Route 70 (Marlton Pike) Cuthbert Boulevard to Penn Avenue

Pedestrian Road Safety Audit/Assessment

Cherry Hill, New Jersey

September 15-16, 2008

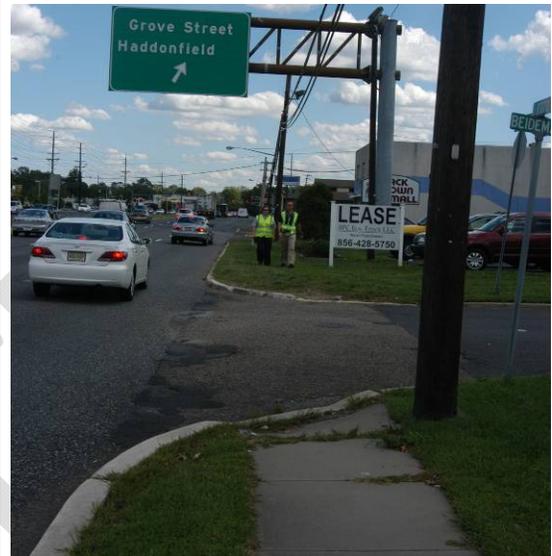
Gaps in sidewalks along Route 70: *Lack of sidewalk and gaps in sidewalk provide limited accessibility for pedestrians along Route 70.* Specific areas with gaps in the sidewalk include the following (see Appendix C for detailed illustration):

- North side of Route 70 from Cornell Avenue to Cuthbert Avenue.
- South side of Route 70 from Washington Avenue to Sayer Avenue.
- South side of Route 70 from Cornell Avenue to Cuthbert Avenue.

Where sidewalk is not installed, pedestrians must travel along driveways, parking lots, and other areas where they may conflict with vehicular traffic.

Suggestions: *Intermediate-* Install sidewalks within existing right-of-way to fill-in gaps along Route 70 between Washington Avenue and Cuthbert Avenue. Where possible, consideration should be given to providing a buffer between the sidewalk and travel way to provide better protection for pedestrians and utilize the full width of the sidewalk (when sidewalk is placed adjacent to the curb, pedestrians rarely use the one and a half foot strip closest to the curb). However, the priority should be to provide a minimum 5-ft wide, unobstructed sidewalk.

Long-term- All sidewalk upgrades within the study area should consider the urban nature of this section of road and should coordinate with redevelopment such as the Market Place at Garden State Park. Upgrades could include streetscaping projects that would create an urban roadway cross section with sidewalk and curb and no shoulder. An urban cross section may help increase driver expectancy of the presence of pedestrians and control vehicle speeds.

View of sidewalk along Route 70 westbound near Cornell Ave. Gaps in the sidewalk limit accessibility for pedestrians.

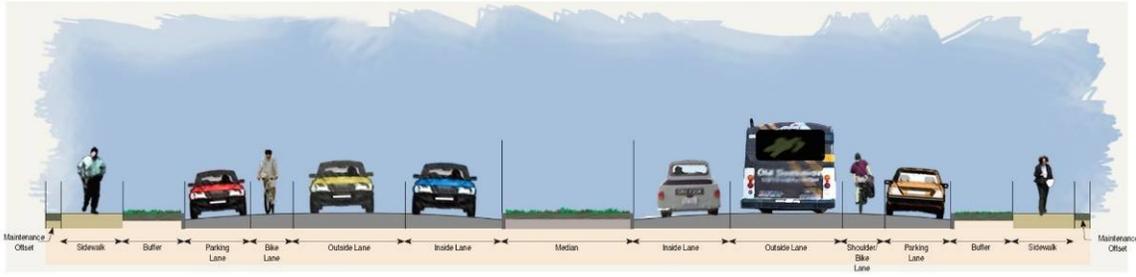
View of sidewalk along Route 70 eastbound near Grove St. Note the gaps in the sidewalk that limit access for pedestrians with mobility restrictions.

A long-term plan for the corridor should consider features such as continuous sidewalks, buffers between sidewalks and the highway, bike lanes/shoulders, and possibly landscaping in the median to allow refuge areas to be constructed at pedestrian crossings. Trees can be planted in the buffer strip to further buffer pedestrians from traffic.

View of sidewalk on the north side of Route 70 traveling westbound. The photo shows the obstructions (i.e., utility poles and vegetation) on the sidewalk near the railroad crossing. The obstructions make it difficult to pass, particularly for those with mobility restrictions or in a wheelchair.

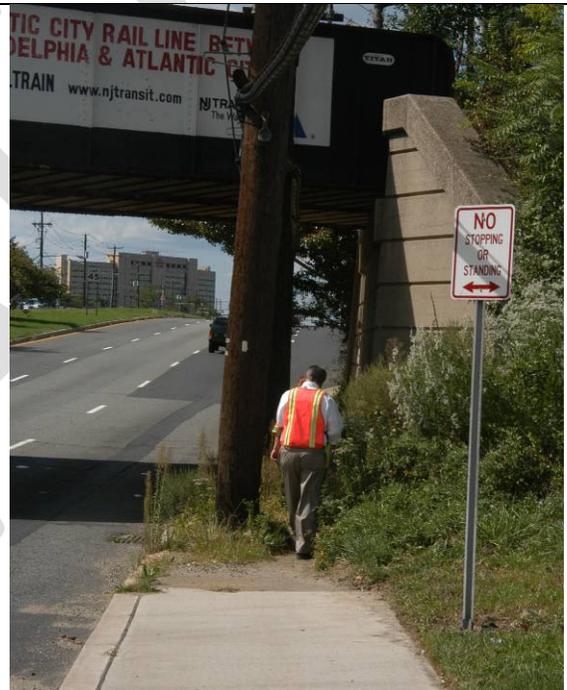
Obstructions on sidewalks: Both permanent and temporary obstructions were found on sidewalks in the study area. Obstructions affect all pedestrians, but are particularly hazardous to pedestrians with mobility restrictions who may require additional space to navigate the sidewalk, or to pedestrians with limited vision who may fail to see the obstructions. Sidewalk obstructions may cause people to use the roadway to maneuver around the obstacles, increasing the potential for a conflict with traffic. Obstructions identified by the RSA team include:

- Utility poles in the sidewalk on the north side of Route 70 near the railroad bridge.
- Vegetation overhanging the sidewalk on the north side of Route 70 near the railroad bridge.

Suggestions: *Short-term-* Maintain the vegetation encroaching on sidewalk.

Intermediate to long-term- Consider removing or relocating obstructions, or building an accessible sidewalk around obstructions. The ability to widen the sidewalk will depend on the available right-of-way and existing bridge structure at the railroad crossing.

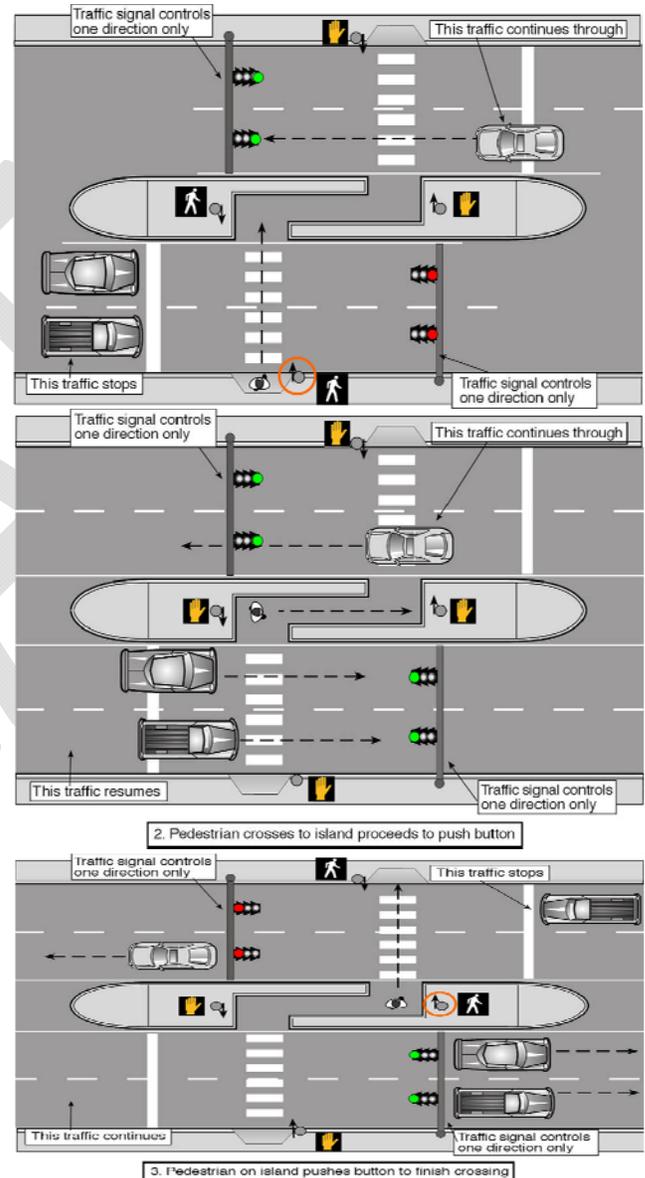
Midblock crossings: *There are several unofficial midblock pedestrian crossings along Route 70 (i.e., pedestrians are crossing between intersections where there is no formal pedestrian crossing). Pedestrians are crossing midblock to access bus stops, commercial developments, and residential properties.* Factors that may affect pedestrians' decisions to cross midblock include the following:

- *High-speed turning traffic:* Right turn channelized islands are designed so that drivers focus their attention to the left to look for gaps in traffic. This means the drivers will be looking away from pedestrians when they are trying to cross an intersection from the right of the driver. Furthermore, curb radii are large enabling vehicles to make faster right turns.
- *Lack of driver yielding:* Driver behaviour and intersection geometry described above may be factors in this issue.

Intermediate- Consider making improvements to existing crossings at intersections to attract pedestrians to these crossings. These improvements may include reducing conflicts with turning vehicles and providing crossings on all legs of intersections. In particular, at the intersection with Cornell Avenue consider modifying the intersection to permit the addition of a pedestrian crosswalk on the west leg of the intersection (see Appendix D for details).

Long-term- Consider new crossing for pedestrians between Cornell Avenue and Cuthbert Boulevard (and relocate bus stops as described in Issue 5). The raised median presents an opportunity to create a pedestrian crossing with a median refuge. The above mentioned NCHRP/TCRP report concluded the compliance rate for drivers yielding to pedestrians on refuge islands with high-visibility crosswalks was lower for higher-speed roadways. The red signal or beacon devices including midblock signals, half signals and HAWK signals had higher compliance rates. Therefore the potential crossing treatments at a crossing between the two intersections include:

- HAWK signal crossing.
- Two-stage signalized crossing.

View of Route 70 just east of railroad bridge. The bicyclist is traveling the wrong way on a 6-lane divided roadway with no shoulder.

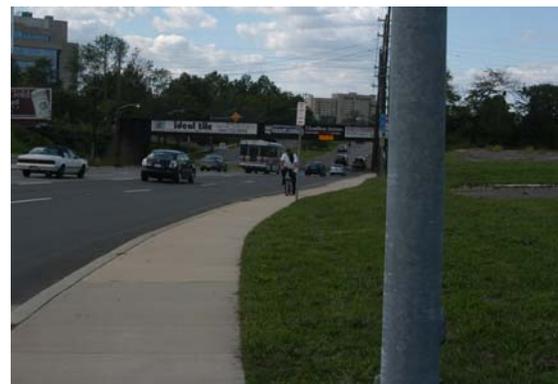
Conflicts with bicycle traffic: The RSA team observed bicyclists riding the wrong way in the road along Route 70 and on sidewalks. This is due in part to the lack of bicycle facilities on Route 70. Without dedicated facilities, bicyclists have to ride in the vehicle travel lanes, on sidewalks, or through parking areas. When bicyclists have no dedicated facilities they travel in unpredictable paths which may lead to frequent and unexpected conflicts with vehicles and pedestrians.

Wrong-way riding on the roadway can be particularly dangerous as motorists turning right out or left into a driveway are focused on finding gaps in vehicular traffic approaching from the opposite direction and may not see a bicyclist traveling in the wrong direction. Potential causes of wrong-way riding may be fewer crossing opportunities to create a convenient network to promote riding in the correct direction and the lack of shoulders, which may discourage bicyclists from biking where they cannot see the potentially conflicting traffic.

View of Route 70 just west of the railroad bridge. The bicyclist is biking on the sidewalk because of lack of a bikeable shoulder. The sidewalk is not wide enough to accommodate bicyclist and pedestrian traffic.

Consider creating bicycle facilities parallel to Route 70. Given traffic volumes and speeds on Route 70, look for opportunities to create paths separated from the roadway. Consider also creating more

frequent crossings as described previously in Issue 2. Also, consider the following tools to promote proper use of bicycle facilities (start with existing facilities and update as new facilities are constructed):

View of channelized right-turn lane and separator island on southbound approach at Haddonfield Road. The RSA team observed pedestrian activity in the area; however, there is no sidewalk or other crossing features in the separator island, resulting in pedestrians crossing at multiple locations.

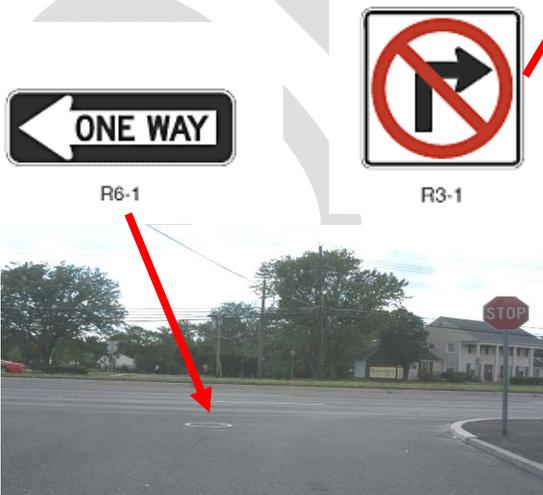
View of channelized right-turn lane on southbound approach at Haddonfield Road. The separator island creates a gap in the connection between sidewalks along either side of the intersection.

Intermediate- Consider providing direct, continuous, and clearly delineated paths for pedestrians across complex intersections (e.g., intersections with right turn separator islands such as at Haddonfield Road). It may be necessary to install a sidewalk and curb ramps on the island before marking a crosswalk. Place advance yield lines and pedestrian warning signage to alert motorists of the presence of pedestrians.

Long-term- Consider alternatives to channelized right turns. Where channelized right turns are to be installed, consider a design with a steeper angle to reduce vehicle speeds and focus driver attention toward the crosswalk.

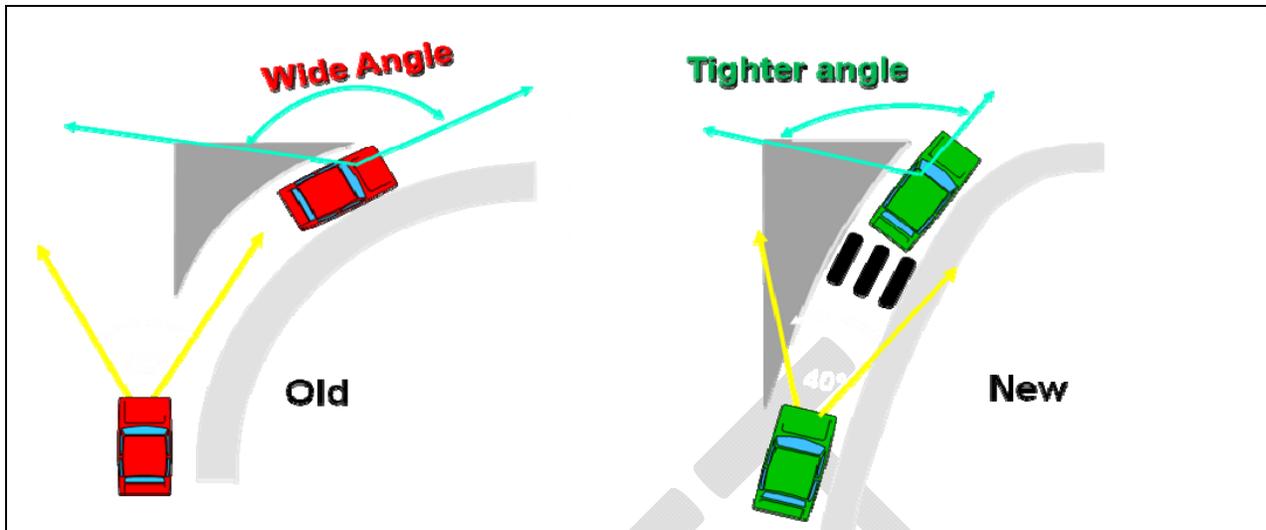
Vehicles make high-speed turns at channelized right-turn lanes: While channelized right-turns can enhance pedestrian safety by providing pedestrians with a refuge island, there are channelized turn lanes in the corridor where wide corner radii enable vehicles to make high-speed right turns. This can expose pedestrians to conflicts with high-speed traffic and make it more difficult for pedestrians to determine when it is safe to cross. Right turn channelized islands are designed so that drivers focus their attention to the left to look for gaps in traffic. This means the drivers will be looking away from pedestrians when they are trying to cross an intersection from the right of the driver.

View of channelized right-turn lane on southbound approach at Haddonfield Road. The wide radius allows vehicles to make high-speed turns, which creates a potential safety issue for pedestrians turning to cross the street.

Intermediate: Consider enhancements in signing and markings to warn motorists of pedestrians. Identify the level of pedestrian activity at Haddonfield Road to determine the need for a crosswalk and other pedestrian features as discussed in Issue 1 (lack of continuity across side streets). For channelized right-turn lanes that lead into an exclusive or acceleration lane, place pedestrian warning signs and advance yield lines prior to the pedestrian crossing. In addition, consider improving all driveways by installing stop bars and stop signs per MUTCD standards.

Long-term: Consider alternatives to channelized right-turn lanes. Where channelized right-turn lanes are to be installed, consider a design with a steeper angle to reduce vehicle speeds and focus driver attention toward the crosswalk.

Source: Oregon Bicycle and Pedestrian Plan
This figure illustrates examples of drainage grates that are bicycle-friendly.

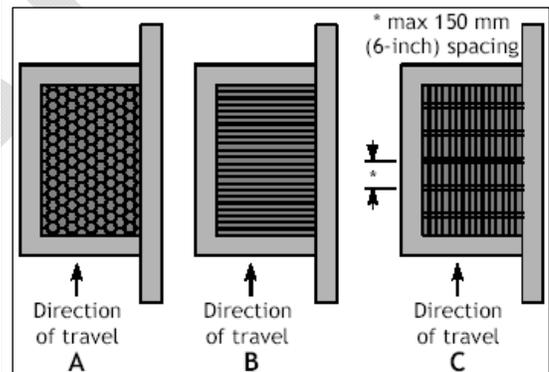
Drainage: The RSA team noted evidence of drainage issues in the right-most eastbound travel lane near Cornell Avenue. Additionally, the drainage inlets in the study area are not bicycle-friendly. Improper drainage can lead to hydroplaning or icy roadway conditions. The drainage inlets have openings that are parallel to the travel way, which creates a hazard for bicyclists (i.e., front tire dropping into drainage inlet).

Intermediate- Consider replacing drop inlets with ADA compliant designs. ADA indicates that gratings located in walking surfaces shall have spaces no greater than 0.5 inches wide in one direction and gratings have elongated openings shall be placed so that the long dimension is perpendicular to the dominant direction of travel. The figure to the right illustrates a few examples of bicycle-friendly designs.
